# **Air Quality Permitting Technical Memorandum**

## **Tier II Operating Permit and Permit to Construct No. 047-00013**

**Holcim (US) Inc., Bliss, Idaho  
Portland Cement Transfer Facility**

**SUBJECT:** Modeling Review for the Holcim (US) Inc. Portland Cement Transfer Facility Tier II Operating Permit Application; Holcim Inc., Bliss, Idaho

**Figure 1 - Holcim Tier II Operating Permit Ambient Air Impacts**

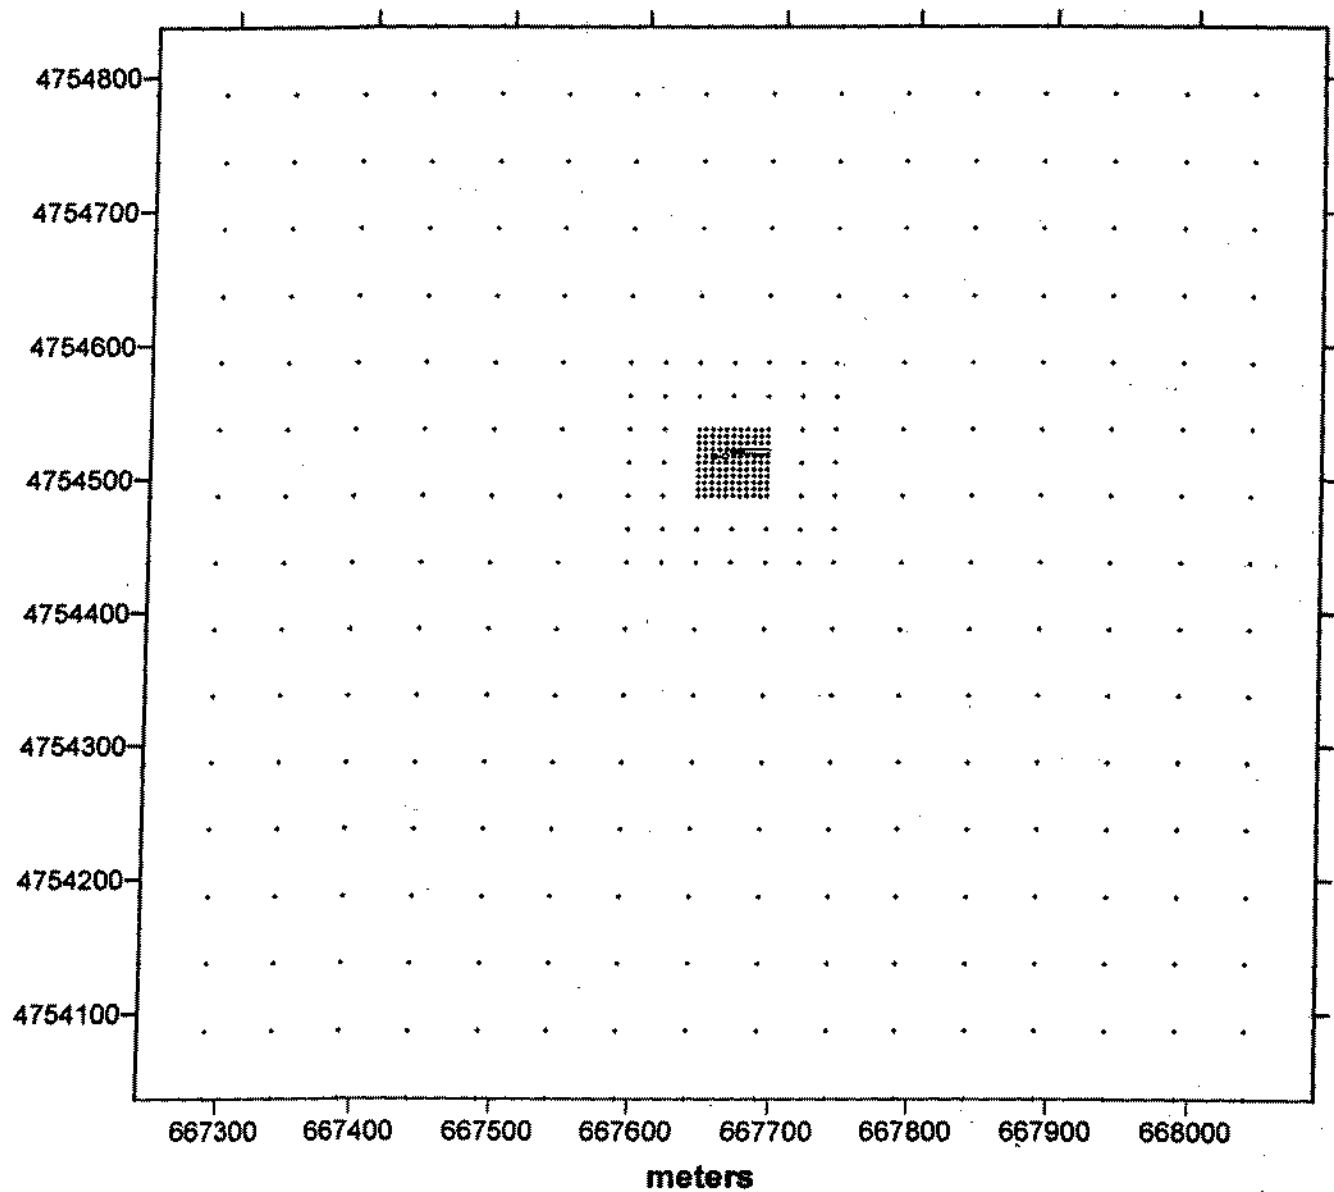
The ambient air impact analysis was performed by Trinity using the model ISC-PRIME - Version 99020. A modeling protocol was submitted to and approved by DEQ prior to Holcim's submission of the Tier II operating permit application. DEQ conducted verification modeling using ISC-PRIME - Version 99020; Table 3 provides a summary of the modeling parameters used for the DEQ analysis. Trinity originally used a receptor grid of 50-meter spacing out to 1,500 meters from the emission source, and a coarse grid of 500-meter spacing out to 5,000 meters from the source. DEQ refined this grid during model verification to the values specified in Table 3. This adjustment was made to provide greater assurance that areas of maximum concentration were identified. Typically, a minimum grid spacing of 25 meters is used for dispersion modeling. The 5-meter spacing along the facility boundary was used for Holcim because the close proximity of the emissions source to ambient air and the plume downwash caused by the presence of the silos resulted in a strong concentration gradient. The maximum modeled concentration could have been missed by a more coarse receptor grid. Figure 1 shows the revised receptor grid used for the modeling analysis.

Modeled concentrations exceeding the 24-hour PM<sub>10</sub> NAAQS, when combined with background concentrations, were derived when the originally estimated emissions rates were modeled by DEQ with the revised receptor grid. DEQ reassessed the emissions estimates to determine if those used in the modeling were representative of actual emissions from the facility. DEQ concluded that emissions were significantly overestimated because cement is only intermittently handled and the emissions estimate submitted by the applicant assumes cement is continuously handled. Emissions were then recalculated using cement handling factors for concrete batching from AP-42, Section 11.12. An emission factor of 0.00034 lb/ton of cement handled was used, in combination with the maximum hourly throughput of 300 ton/hr, to generate a revised emissions rate of 0.10 lb/hr.
